Memorandum - March 28, 2025

To: NCTCOG – iSWM Implementation Subcommittee

From: Baird, Hampton, and Brown

Subject: Sedimentation Basin Guidance Overview

Fig. 1—Definition sketch.

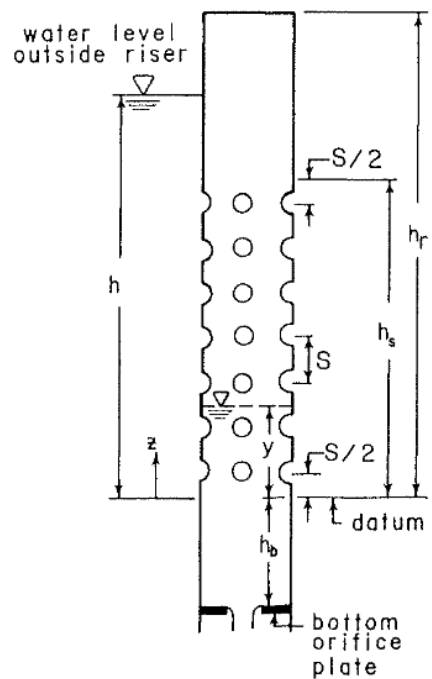
The Technical Manual, Section 3.9.3, Outlet and Spillway, page CC-125, does give general direction regarding outfall types, configurations, and some minimal design procedures. The full design procedure, for sedimentation basin outlets, is given in the Hydraulics Technical Manual in Section 2.2. However, in Section 2.2.2 the equation given for the perforated riser pipe is for a single scenario out of three possible scenarios. All three scenarios are given in the original research paper, *1988 McEnroe – Hydraulics of Perforated Riser Inlets for Underground Outlet Terraces* (McEnroe, 1988). Equation 6, below, is provided in the Hydraulics Technical Manual, Section 2.2.2, which is used when the water surface elevation in the pond generally remains within the limits of the perforations and has no tailwater within the limits of the perforations, as this is the most likely situation. Equation 8 is used when the water surface elevation is above the limits of perforations and equation 10 is used when the tailwater extends above the limits of the perforations. Including all three equations (see equations below) and their supporting documentation in the hydraulics manual would allow the full use of design of the perforated riser pipe.

Equation 6

Where $h < h_s$ and $y < 0$

$$Q = \left(\frac{2}{3}\right) \left(\frac{C_s A_s}{h_s}\right) \sqrt{2g} \sqrt[3]{h}$$

Equation 8

Where $h_s < h < h_r$ and $y > 0$

$$Q = \left(\frac{2}{3}\right) \left(\frac{C_s A_s}{h_s}\right) \sqrt{2g} (\sqrt[3]{h} - \sqrt[3]{h - h_s})$$

Equation 10

Where $y > h_s$

$$Q = (C_s A_s) \sqrt{2g(h - y)}$$
